# UNITED STATES PATENT AND TRADEMARK OFFICE

| APPLICATION NO. | FILING DATE | FIRST NAMED INVENTOR | ATTORNEY DOCKET NO. | CONFIRMATION NO. |
|-----------------|-------------|----------------------|---------------------|------------------|
| 10/709,172      | 04/19/2004  | Brian Arnott         | 060494-0001         | 1757             |

# Office Action Summary

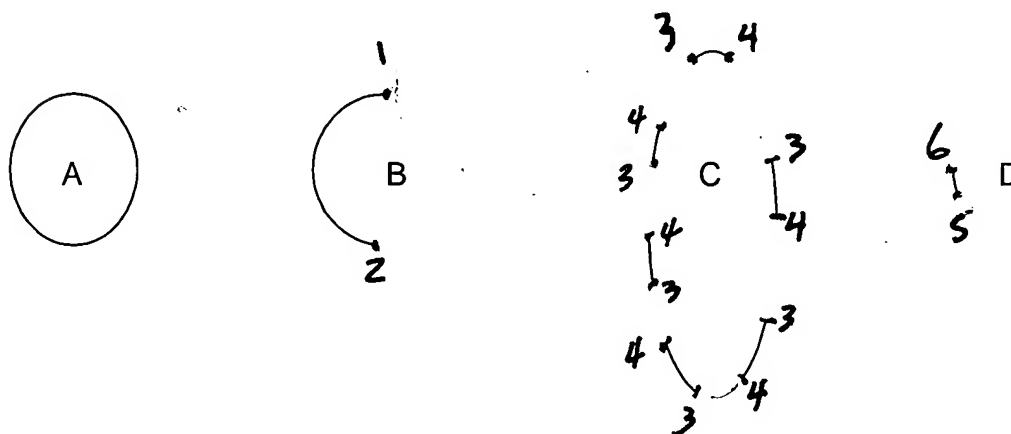
Claims 31 – 35 are rejected under 35 USC Sec. 112(2) for failure to particularly point out and distinctly claim the invention. Claims 31 recites "surrounding the oil container at least in part." It is unclear what it means to "surround" something "in part." For example, while it is clear that in the diagram below that "A" is surrounded by the circle, it is unclear whether "B", "C" or "D" are surrounded at least in part by their respective corresponding arcs 1-2, 3-4, and 5-6.

In short, the concept of surrounding in part is not per se impermissible under 35 USC Sec. 112(2). But the term "surrounded . . . in part" in claim 31 is a relative term which renders the claim indefinite. The term is not defined by the claim, the specification does not provide a standard for ascertaining the requisite degree, and one of ordinary skill in the art would not be reasonably apprised of the scope of the invention. There does not even appear to be a recognition in the art that "surrounded at least in part" means "extending through at least 50% of a circumference of," or the like.
